# Planning Scheme Amendment C339ggee Flood overlays and zones

## REVIEW OF COMPLEX SUBMISSIONS – LARA, AVALON AND FYANSFORD

City of Greater Geelong

July 2022

**Figure 34 Properties within NGA with Exhibited Overlays**

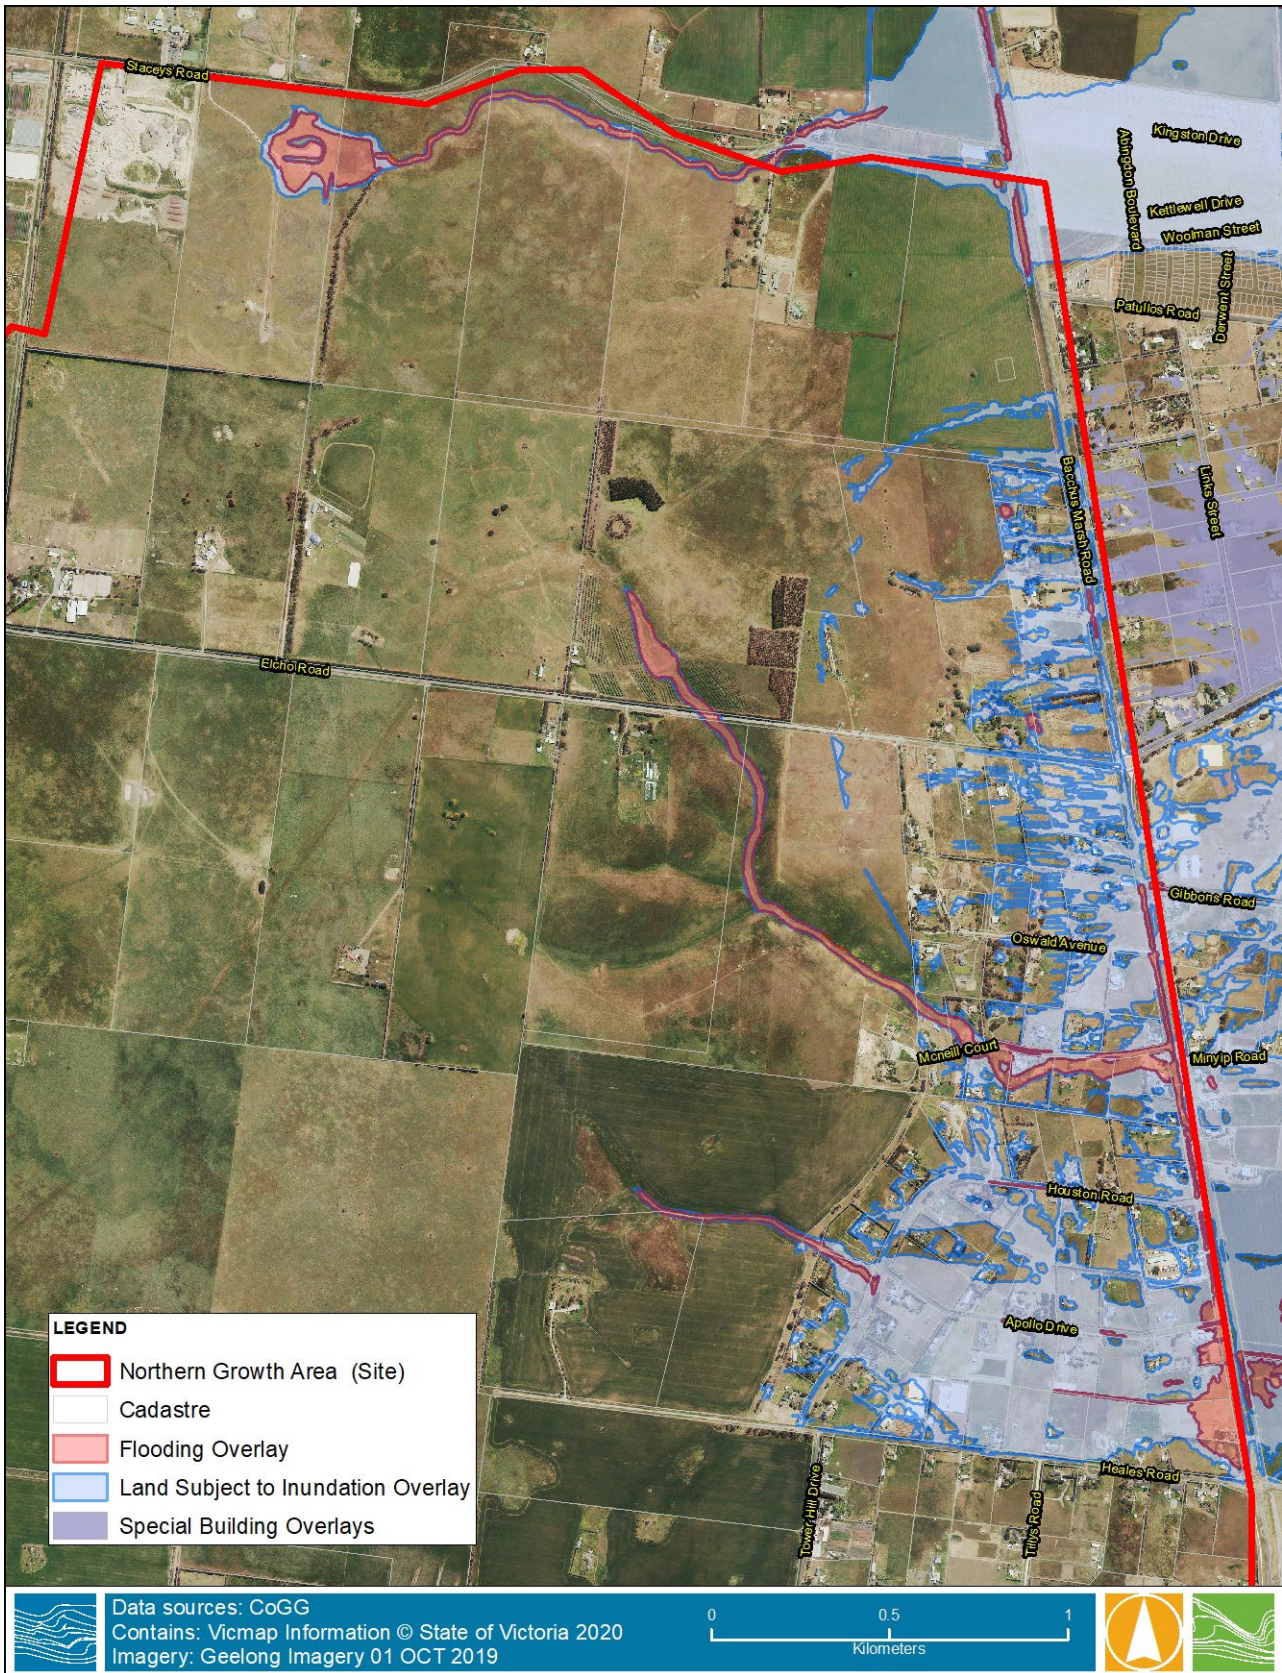
While it is understood that Lovely Banks are undertaking significant planning works in relation to the future development of their site, it should not be expected to preclude the exhibited overlays from being included within the current amendment. The Elcho Road PSP work is relatively high level and would not likely provide the ‘best available’ flood information for the current conditions. There are a number of existing properties within the NGA that have been identified as being at risk from flooding (Figure 25). Exclusion of the NGA and these properties could leave the City liable by not providing the most up to date and ‘best available’ flood information as part of the amendment.

As timelines for the NGA works have not been finalised and considerable design work still to be completed it is recommended that proposed overlays are excluded for this area with Amendment C339. Future adjustments to flood overlays associated with PSP investigations could be implemented at a later date as separate amendments.
